1 APPLICATION SUMMARY

Application information	
Lot, Plan and Address	Lot 304 SP329491, 167-191 Christensen Road South, STAPYLTON QLD 4207
City Plan version	City Plan Version 13
Type of development, proposed use and level of assessment	Material change of use (code assessment)
Applicant and consultants	VPH07 Pty Ltd (A.C.N. 690 603 591) - Applicant Zone Planning Group – Town Planning VICTO – Building designer Studio 8 Concept + Design – Landscape consultants CLA Consultants – Civil Engineers
Land owner	VPH07 Pty Ltd (A.C.N. 690 603 591)
Officer's recommendation	Approval, subject to conditions

The purpose of this report is to assess an application for a development permit for a material change of use (code assessment) to establish Industry (15 tenancies) at Lot 304 SP329491, 167-191 Christensen Road South, Stapylton.

Figure 3: Site Plan (Source: VICTO)

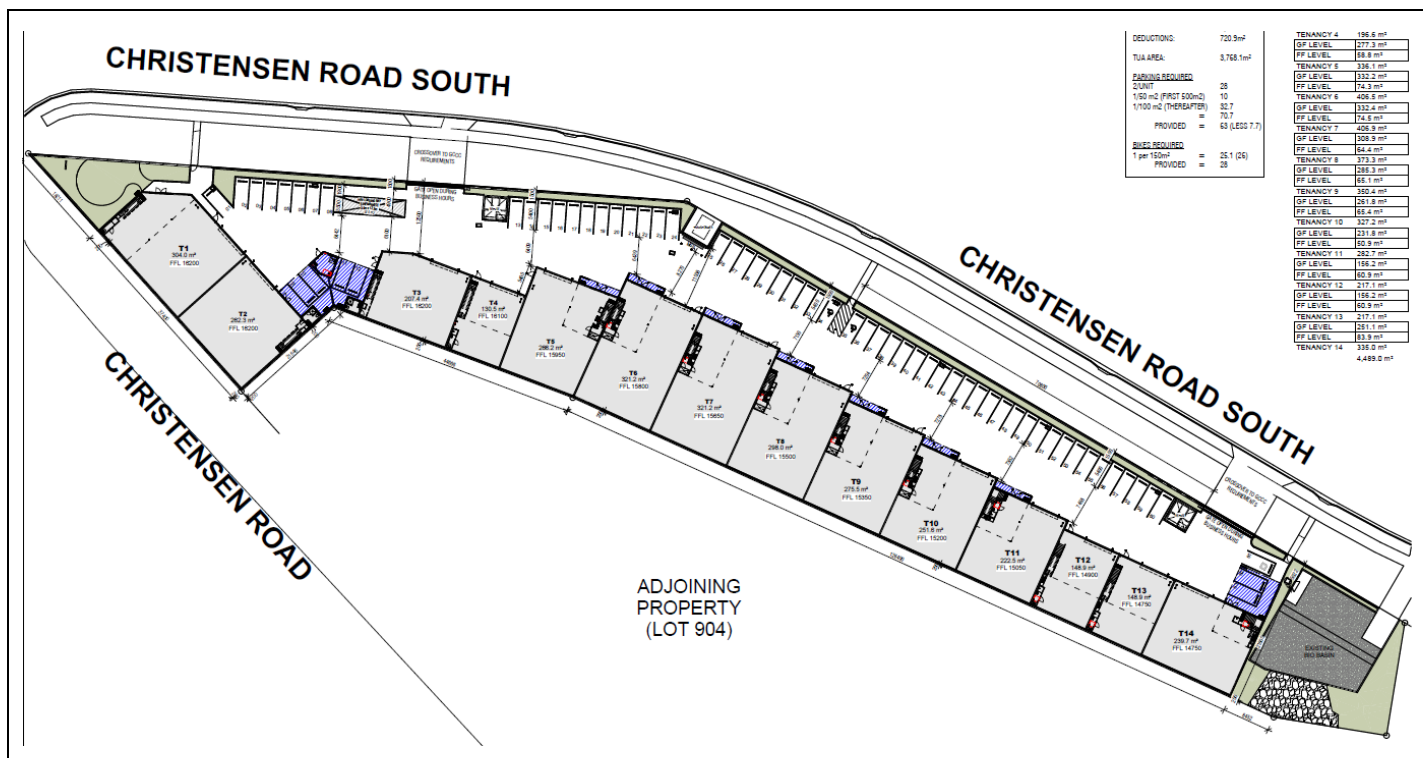
Subject matter	Benchmark		Comment
	PC	AS	
M38 Industrial Estate Place Code			
Building setback	PC4	AS4.3	AS4.3 of the M38 Industrial Estate Place Code requires a 3m setback from the common boundary of public open space which includes a fence and landscape buffer strip. PC4 requires that <i>“The layout of buildings, structures and activities achieves an attractive and orderly appearance where development is visible from the public domain. A good standard of visual amenity is achieved through generous building setbacks and high quality landscaping.”</i> The site is constrained by its narrow, elongated shape and the open space to the rear is densely vegetated which will visually screen the rear of the development. The rear of the building will not be readily visible from the public domain which is considered to comply with PC4. Further to this, a condition is recommended requiring the building and retaining walls to be setback from the public open space by 600mm in accordance with Planning Scheme Policy 11 - Land Development Guidelines and Condition 50 of the Preliminary Approval (MIN/2023/64).

Vehicular parking	PC8	AS8.1.2	To comply with AS8.1.2 of the M38 Industrial Place Code, the development must provide 71 car parking spaces based on 14 tenancies with total TUA 3,768m². The submitted drawings show a total of 63 car parking spaces resulting in a shortfall of 8 car parking spaces. In addressing PC8, the applicant has relied on on-street parking as the site has a road frontage able accommodate this shortfall. Planning Assessment supports the reduced on-site provision on the following grounds: • The proposed supply equates to approximately 4 car parking spaces per tenancy. • Tenancy sizes ranging from 150m² to 300m². • The site has approximately 220m of frontage, which could potentially accommodate up to 35 on-street parking spaces. • On-street parking is also available on both sides of Christensen Road South. • Reliance on on-street parking is common within industrial areas. Based on the above assessment it is considered the development complies with PC8 of M38 Industrial Place Code.

Subject matter	Benchmark		Comment
	PC	AS	
Siting	PC14	AS14	An acceptable solution is not provided so the application is assessed against the PC. PC14 requires that <i>"All buildings must be sited to complement the industrial character and the predominant built form of the surrounding area and to reduce potential conflicts between uses..."</i> A condition is recommended requiring the building and retaining walls to be setback from the public open space by 600mm in accordance with Planning Scheme Policy 11 - Land Development Guidelines and Condition 50 of the Preliminary Approval (MIN/2023/64).
Siting	PC15	AS15	An acceptable solution is not provided so the application is assessed against the PC. PC15 requires that <i>"The layout of the site must provide a clear separation between the public access areas and the areas set aside for servicing the building"</i>. The building and retaining walls will be setback from the public open space at the rear by 600mm with fencing along the boundary in compliance with PC15. The front of the proposed development does not comply with PC15 as pedestrians parking along the road frontage will need to cross over the service vehicle paths to access the tenancies. However, given the development layout is constrained by the elongated lot configuration, this is accepted as a technical non-compliance.

Siting	PC16	AS16	An acceptable solution is not provided so the application is assessed against the PC. PC16 requires that: <i>"Industrial structures, storage or service areas, which are likely to appear visually dominating or unsightly, are located to the rear or sides of sites or are otherwise designed and screened to enhance their appearance, when viewed from the street"</i>. While the servicing of tenancies will be visible from the street, given the development layout is constrained by the elongated lot configuration, this is accepted as a technical non-compliance.
Design of Carpark Areas	PC21	AS21	The external width of the bed along the Christensen Road South frontage varies between 1.2 to 1.5m in lieu of 3m. To comply with PC21 a condition is recommended requiring an increase in the width of the front garden bed by approximately 0.6m by extending the garden bed to the proposed wheel stops.

Landscape Design	PC25	AS25.1	The front landscaping buffer does not provide the required five metre buffer for 25% of the frontage as required by AS25.1. As such, the development does not comply with AS25.1 and is assessed against PC25. The proposed development contains landscaping along all street frontages. To comply with PC25 a condition is recommended requiring an increase in the width of the front garden bed by approximately 0.6m which will contribute to the landscape character of the industrial area.
Amenity Protection	PC46	AS46	An acceptable solution is not provided so the application is assessed against the PC. The proposed development will enhance visual amenity of the surrounding industrial area through the use of landscaping and the high-quality architectural design of the building. The subject site is located approximately 800m from the closest sensitive receivers so is not expected to adversely impact the amenity of any sensitive receivers.

Car Parking, Access and Transport Integration Constraint Code			
Access to car park areas	PC9	AS9.1	The submitted drawings show gates at both vehicle access points, so compliance with Acceptable Solution AS9.1 is not achieved. A condition of approval is recommended requiring that the security gates remain open during the hours of operation, ensuring unrestricted access for employees and visitors. Based on the above assessment and the proposed condition of approval it is considered the development complies with PC9 of the Car Parking, Access and Transport Integration Constraint Code.
Loading bay and set down area and design service vehicle requirements	PC13 & PC14	AS13 & AS14.1	To comply with Acceptable Solutions AS13 and AS14.1 of the Car Parking, Access and Transport Integration Constraint Code, the development must be designed to accommodate a 20m Articulated Vehicles (AV) through the provision of loading areas. The submitted drawings show a loading bay which can accommodate a Heavy Rigid Vehicle (HRV), and swept path assessment has been provided demonstrating the ability of the HRV to access the site in forward gear manoeuvre within the site and exit in forward gear. Transport Assessment has undertaken an Articulated Vehicle (AV) swept path which demonstrates that, if required, an AV is capable of entering and exiting the site in forward gear and can utilise the circulation aisle for temporary loading. Based on the above assessment it is considered the development complies with PC13 and PC14 of the Car Parking, Access and Transport Integration Constraints Code is achieved.
